**RE: COA-25-000586
REVIEW OF YOUR CERTIFICATE OF APPROPRIATENESS APPLICATION
3520 MEADOW ST**

Routine	January 7, 2026	PLANNER:	Rhonda Dunn, Ph.D.
FILE NUMBER:	COA-25-000586	DATE FILED:	January 7, 2026
LOCATION:	3520 MEADOW ST	DISTRICT:	H/100
COUNCIL DISTRICT:	7	CENSUS TRACT:	481130037001
ZONING:	PD-595		
APPLICANT:	Mustafa Jawadwala Murai Homes, LLC		
REPRESENTATIVE:			
OWNER:	Murai Homes, LLC

The staff decision is: Routine Maintenance - Approved w/ Conditions

B PROPOSED RIGHT ELEVATION
SCALE:
24X36 SHEET: 1/4" = 1'-0"
11X17 SHEET: 1/8" = 1'-0"

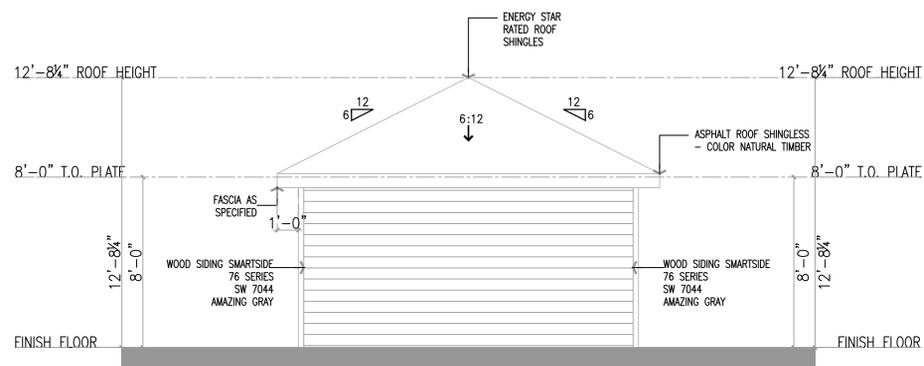
- 1) Windows and Doors We are adding a window on the right elevation.
Approve with Conditions

Approve the alteration in fenestration of accessory structure with the understanding that the new window will match the approved window on the left elevation of the structure in material, dimensions and lite configuration and that only one window is to be added to the accessory structure. Implementation of the recommended conditions would allow the proposed work to be consistent with the Wheatley Place preservation criterion Section 10.2 pertaining to Accessory Buildings.

Conditions: that the new window will match the approved window on the left elevation of the structure in material, dimensions and lite configuration and that only one window is to be added to the accessory structure.
